Site Specific Management Plan 001 - [sector 320]
MacKays to Peka Peka Expressway

17 DECEMBER 2014 - REV C - CERTIFIED ISSUE

SITE SPECIFIC MANAGEMENT PLAN - RAUMATI SOUTH [SSMP 1 - SECTOR 320]

Title: SSMP 1 [320] - SHEET 4 SECTIONS

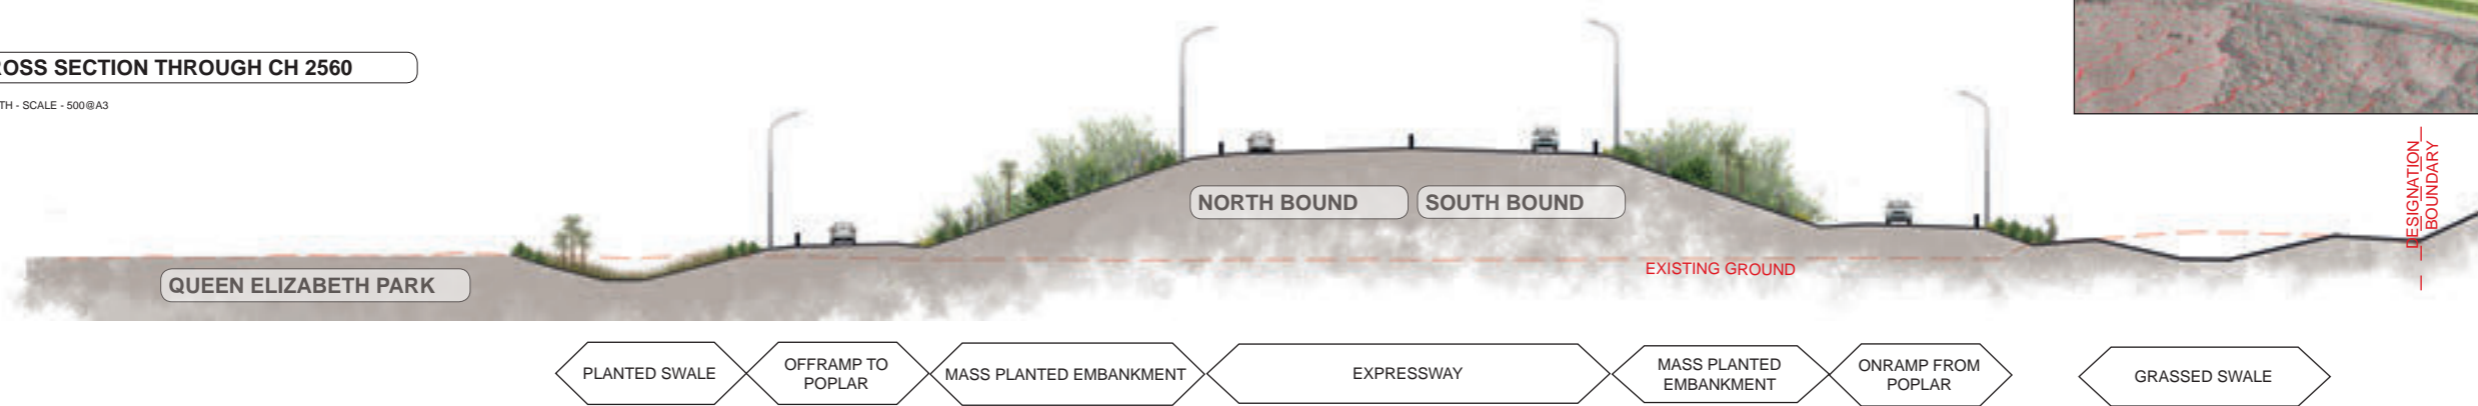
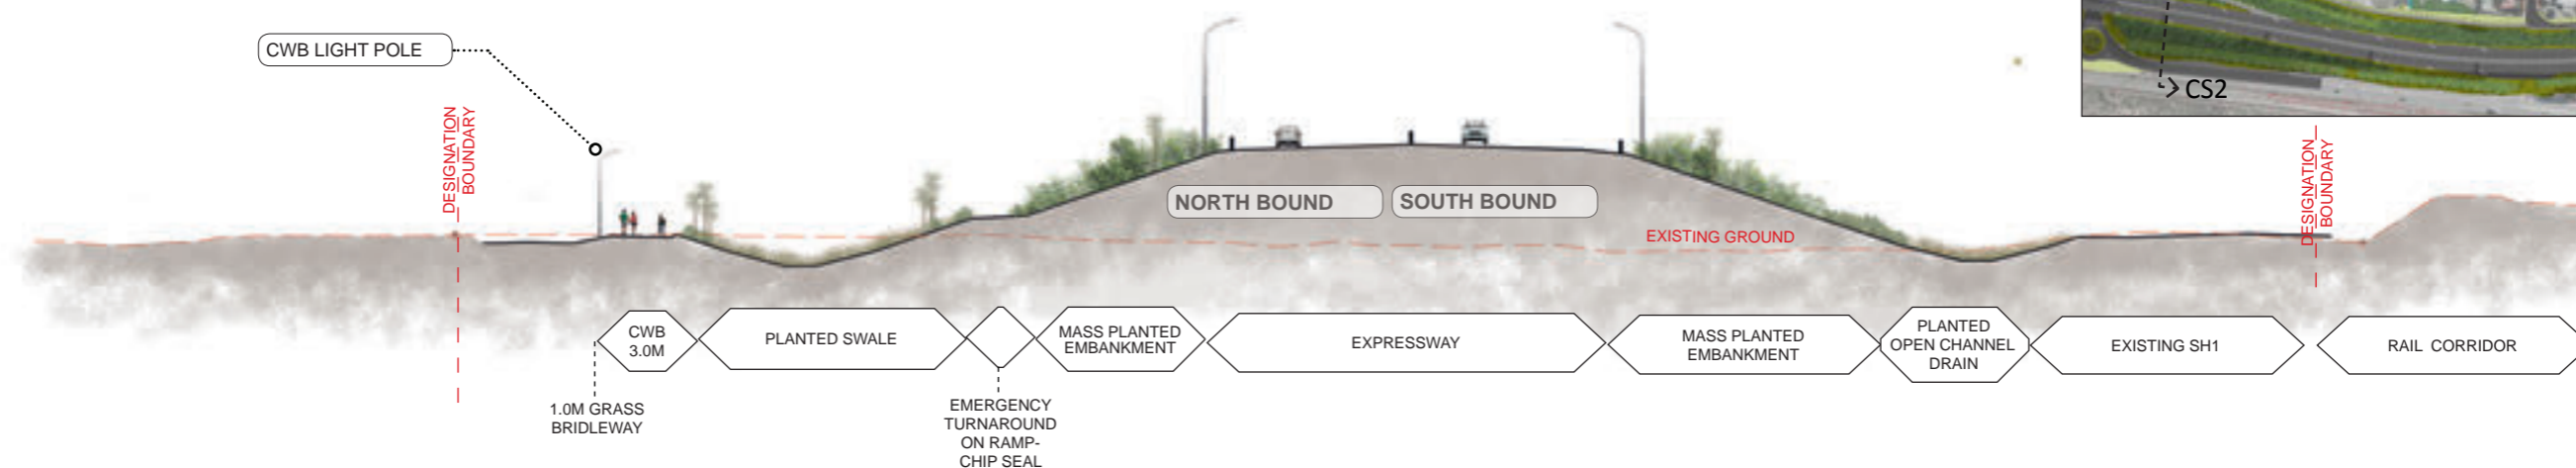
COMMENTS ON DRAFT ISSUE SSMP1: RAUMATI SOUTH			
KCDC REVIEWERS COMMENTS [JW=Julia Williams- Landscape Architect; DP = Deyana Popova-Urban Designer]			
<i>Draft issue for comment 1.9.14, follow up feedback meeting 5.9.14</i>			
<i>Page</i>		<i>Reviewers Comments</i>	<i>Management Plan Author's response</i>
		Would like to see an additional cross section that runs through the Leinster Ave residential properties.	Two additional cross sections added to SSMP 1
		CWB entrance: given its importance as the start ('gateway') of the CWB, keen to see this as a bespoke design rather than 'standard' treatment. Including bespoke design of gate to Emergency Turnaround on ramp.	Referred to design team – looking to include a flat area at entrance for informal seating / picnic and provision for future signage kiosk.
		Include cross section illustrating how the brown rock with 1.0m topsoil will be handled to ensure topsoil is keyed in place and the topsoil depths and associated planting.	This has be included in the SSMP 1 - sheet 4.

PROPOSED PLAN- POPLAR AVENUE CROSSING - 1:500@A3

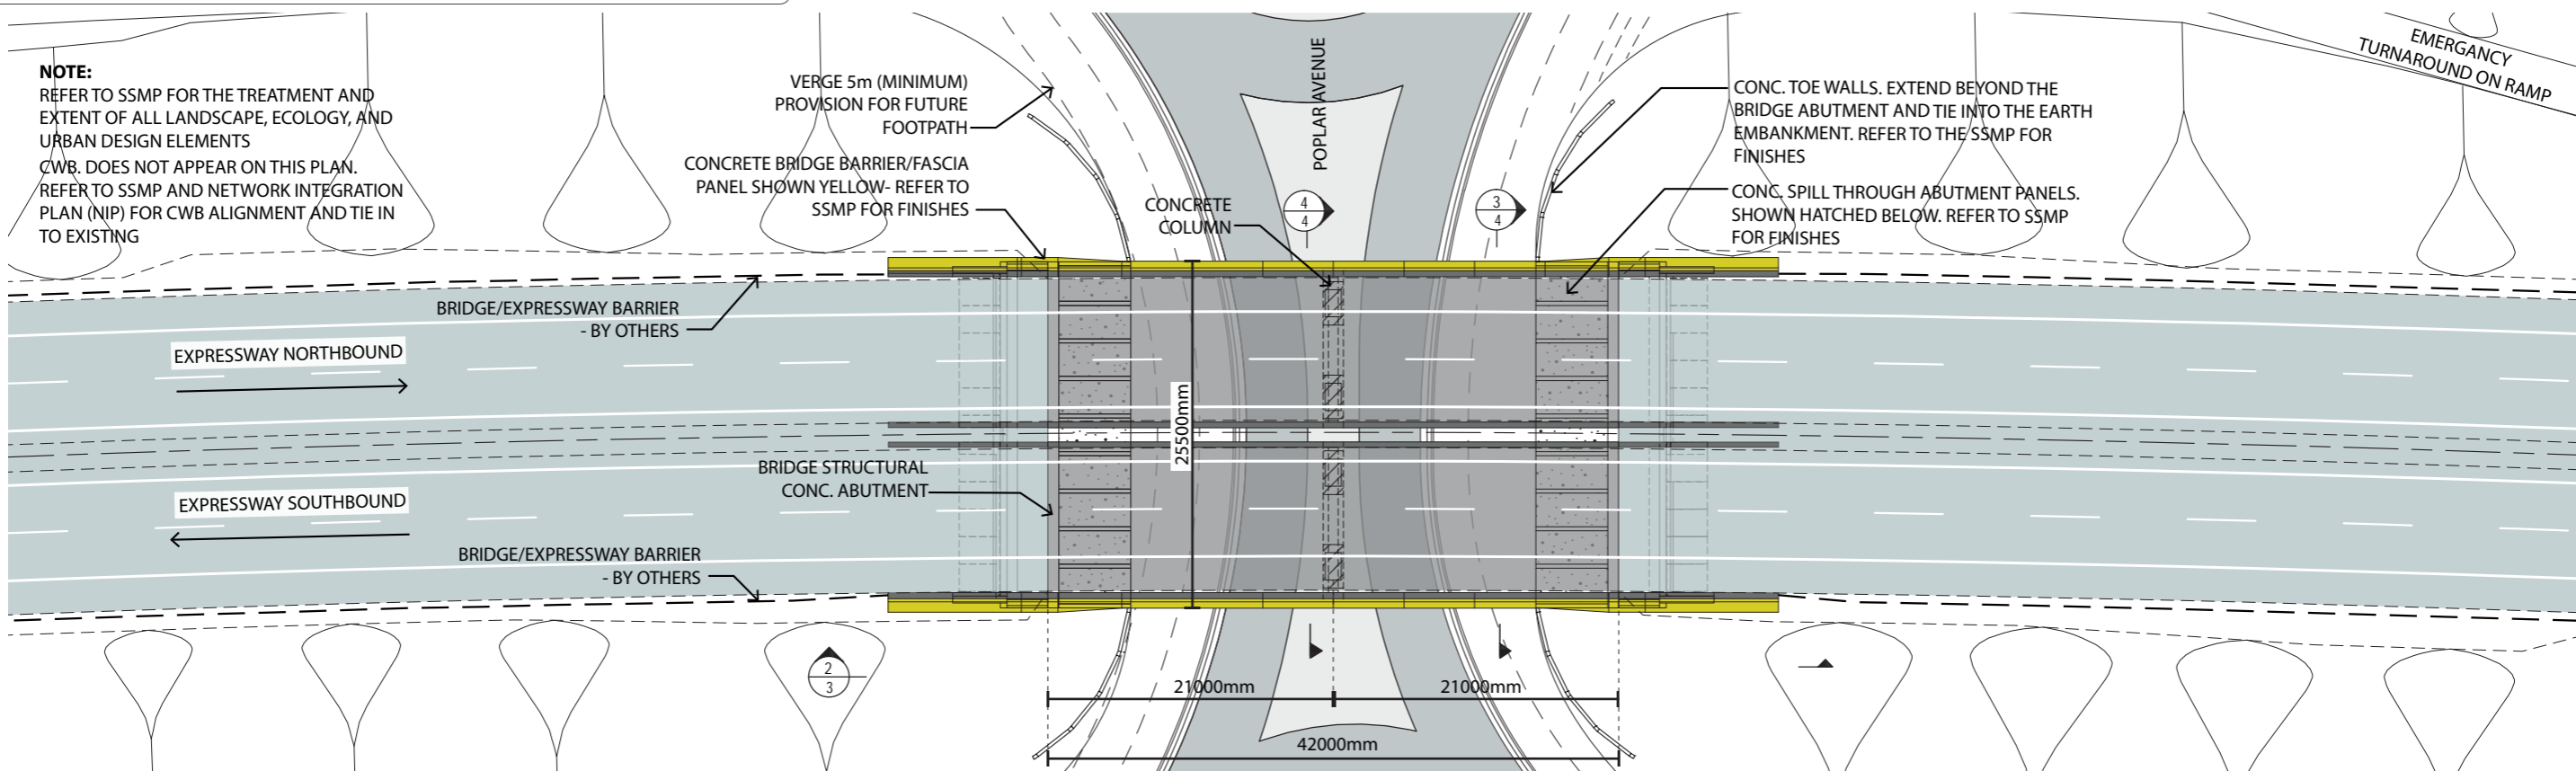
1. Reduced bridge Length. Reduced number of spans from 3 to 2
2. Column locations and number adjusted
3. Column profile developed
4. Local road design developed
5. Removed footpath from under Poplar Ave bridge

2. PROPOSED ELEVATION - POPLAR AVENUE CROSSING EAST ELEVATION - 1:250@A3

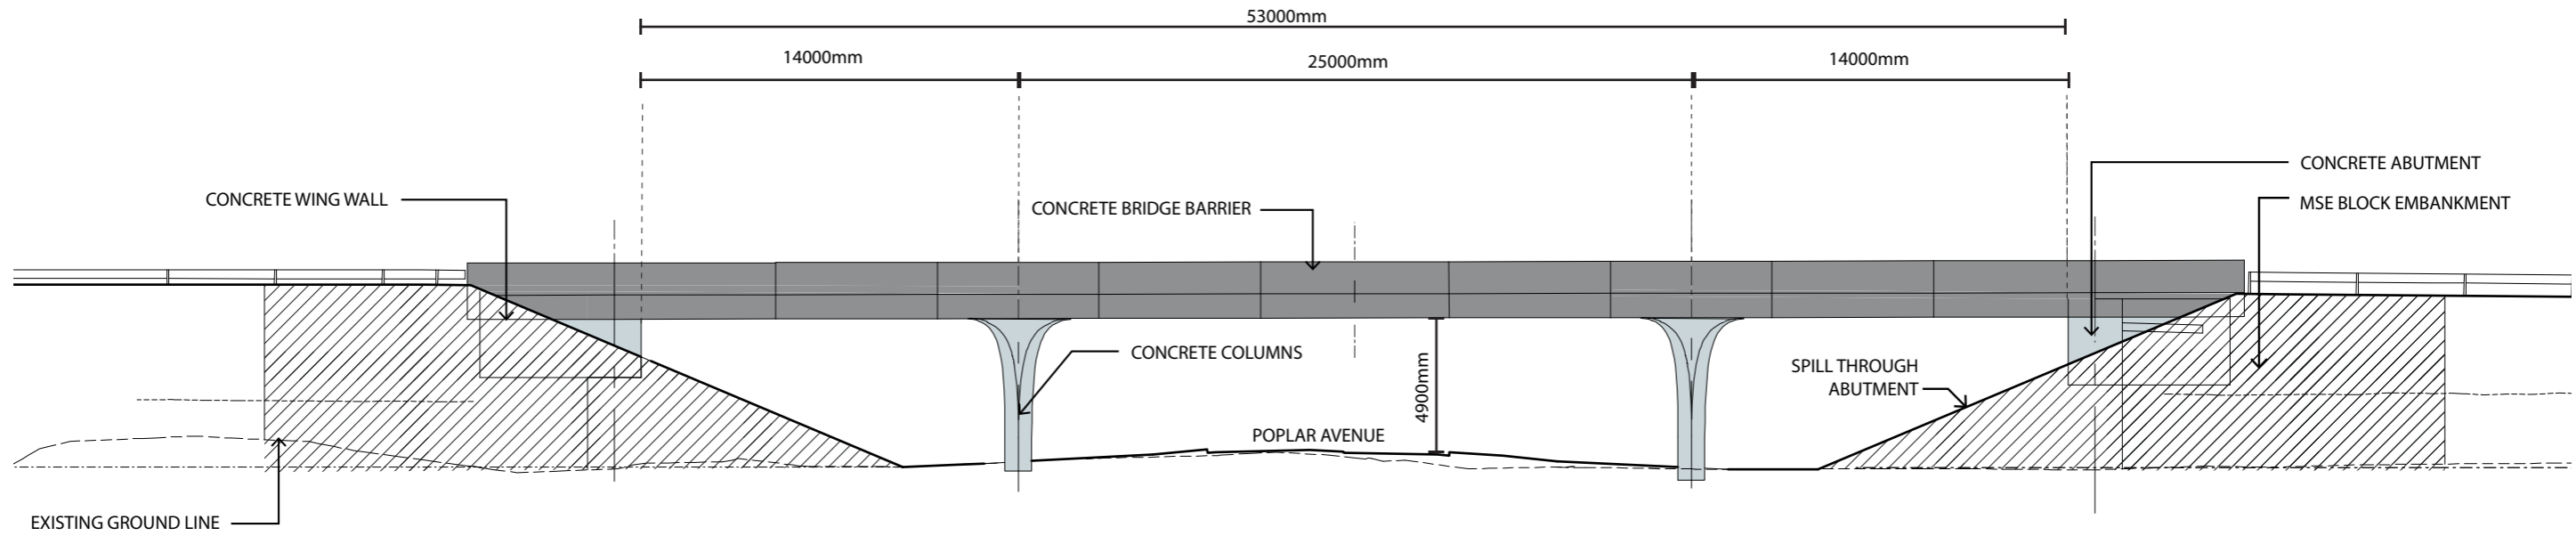
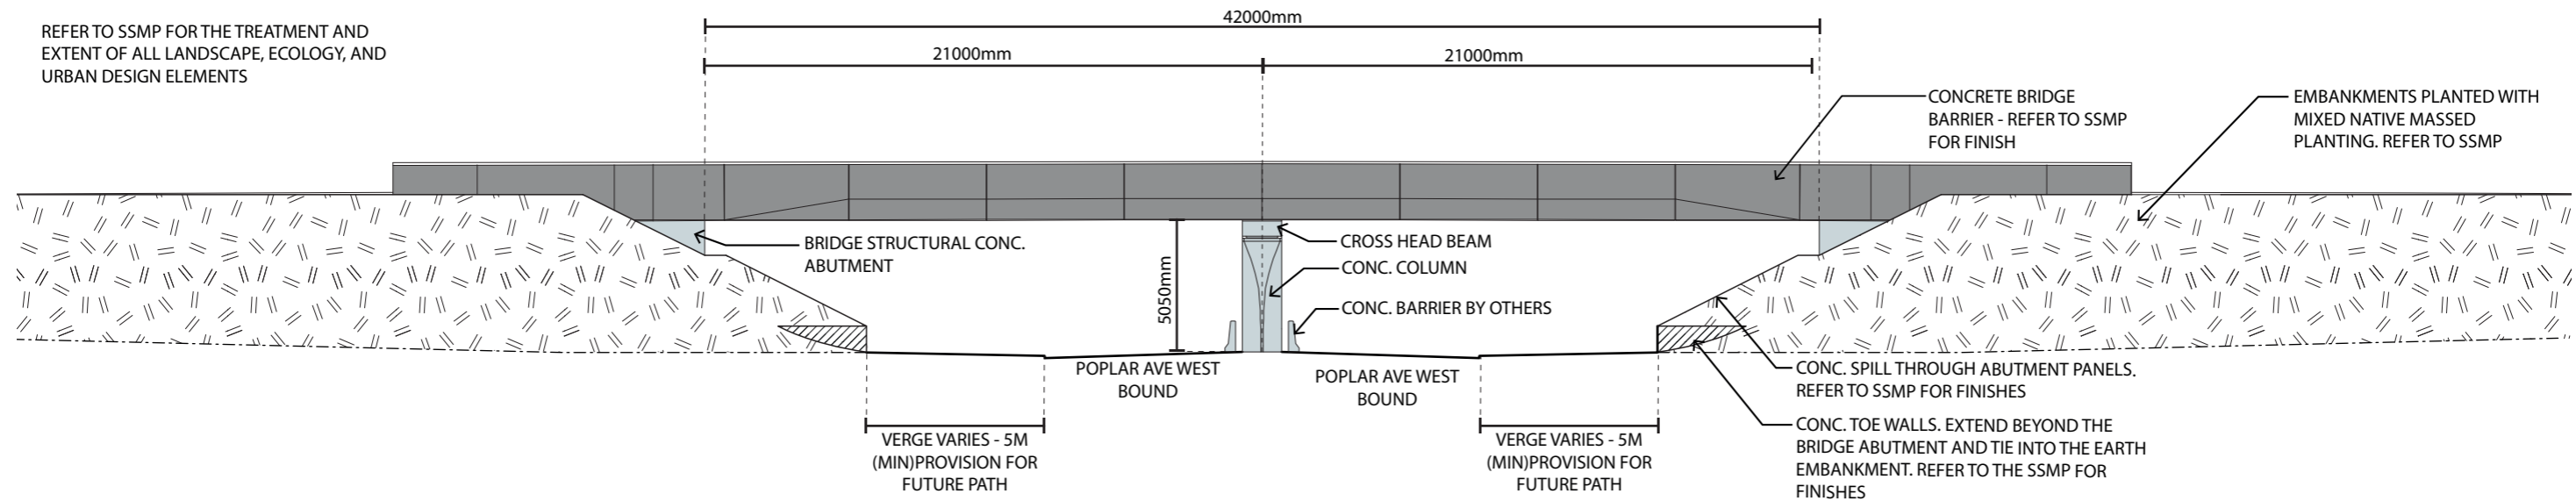
- 1. Reduced overall length of bridge, Reduced number of spans from 3 to 2
- 2. Column locations adjusted
- 3. Column profile developed
- 4. Local road design developed
- 5. Removal of footpath under Poplar Ave bridge

- 1. More efficient bridge design. Columns no longer sit between the verge and spill through abutments.
- 2. Reduced number of spans, reduce columns - 4 columns vs 8. Columns moved away from pedestrians.
- 3. Increased structural core based on geotech investigations carried out post AEE, while still providing the sculptural outer.
- 4. Local road design refined since AEE. Roundabouts are closer increased central median to allow for centrally placed columns
- 5. CWB Connects to old SH1 via Leinster Ave pedestrian bridge. Provision for future pedestrian/cycle link as part of KCDC SH1 revocation work. Refer to SSMP for more detail.

3. PROPOSED SECTIONAL ELEVATION - POPLAR AVENUE CROSSING (NORTH ABUTMENT) - 1:200@A3

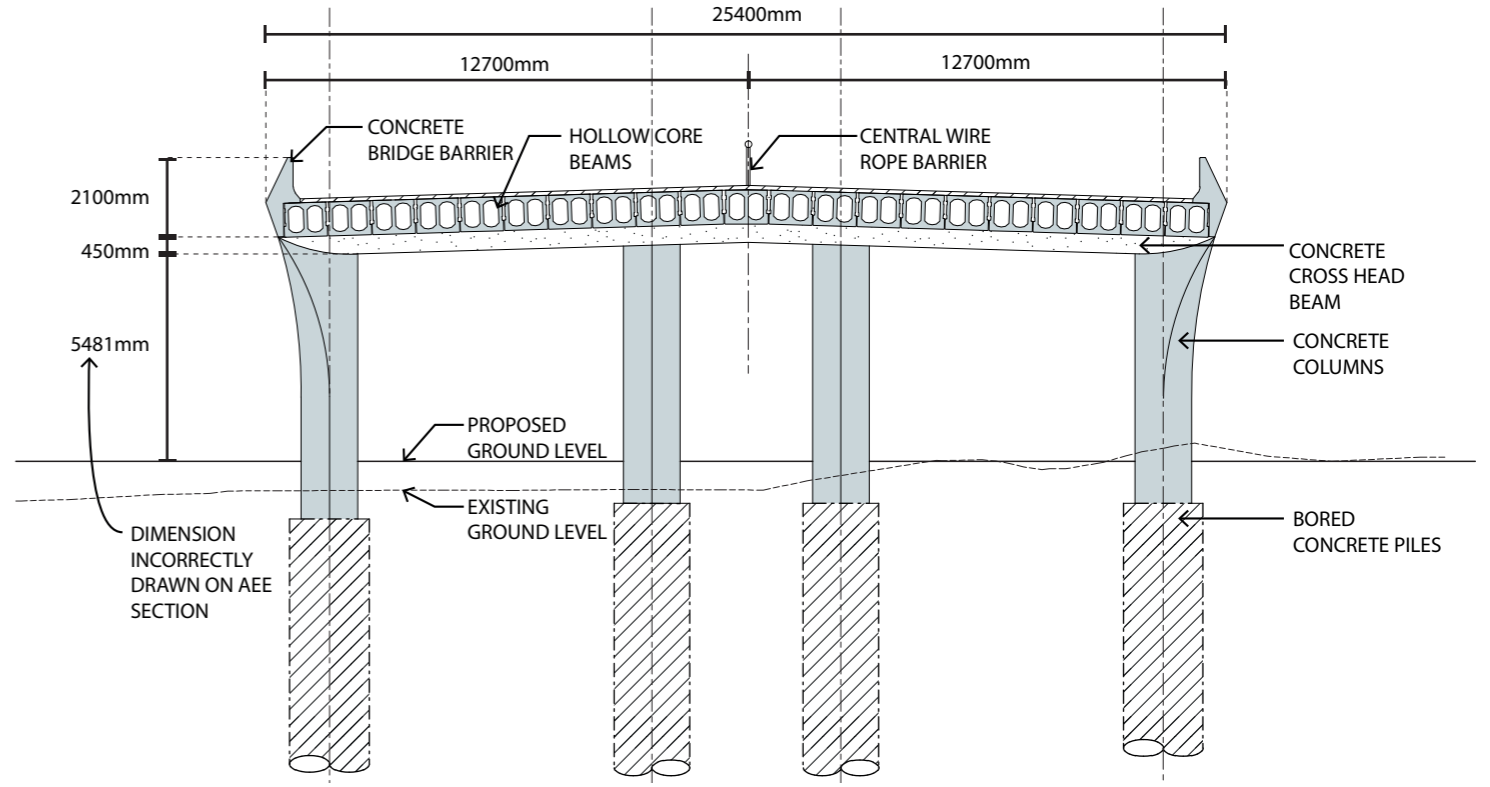
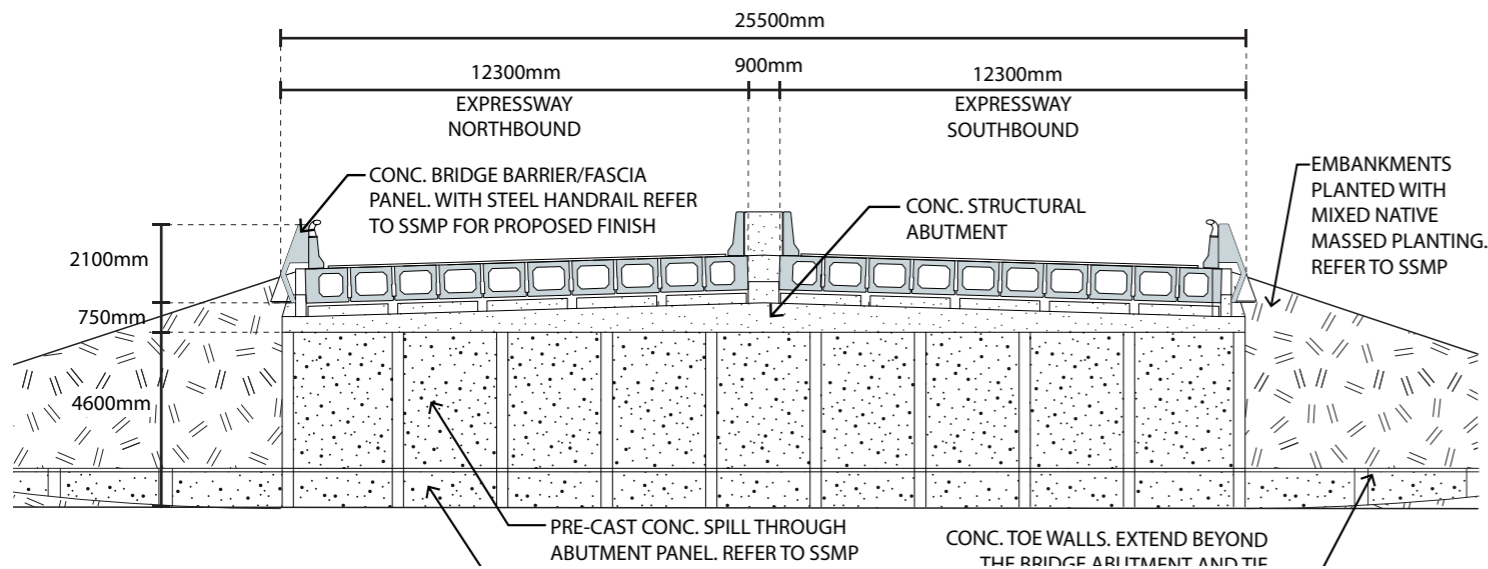
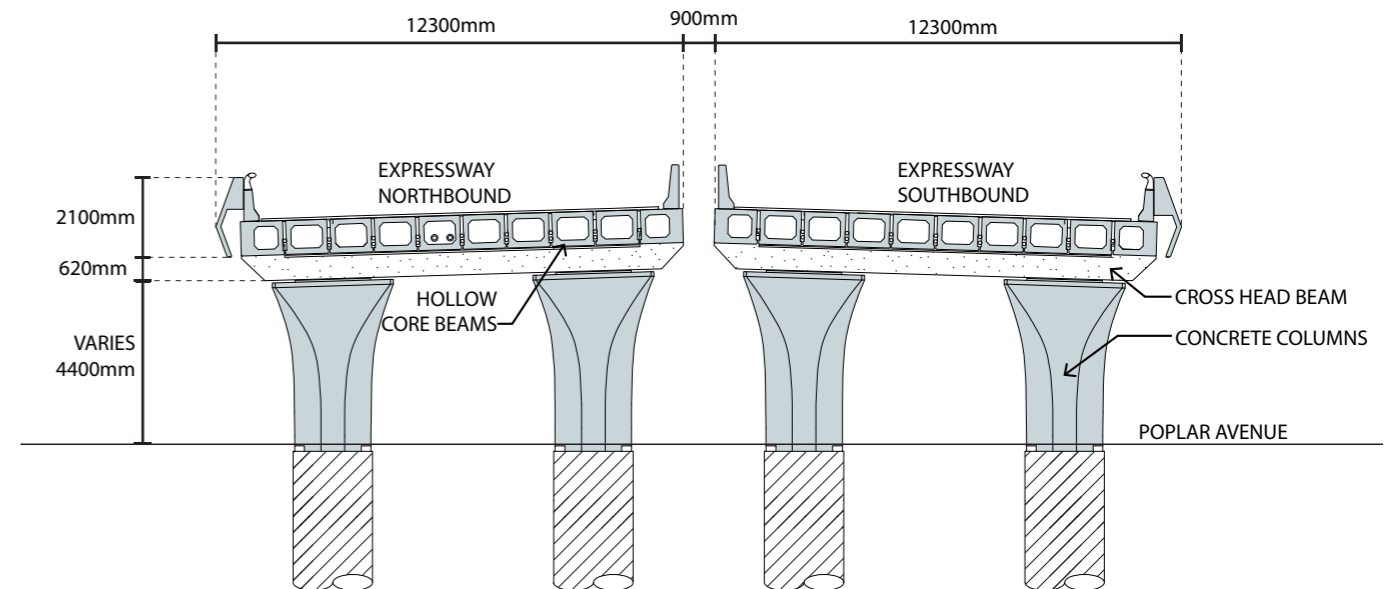
1. More detail provided for abutment treatment
2. Cross head depth has increased
3. Column profile developed
4. Simply supported structure
5. Change to split deck
6. Handrail shown on top of barrier
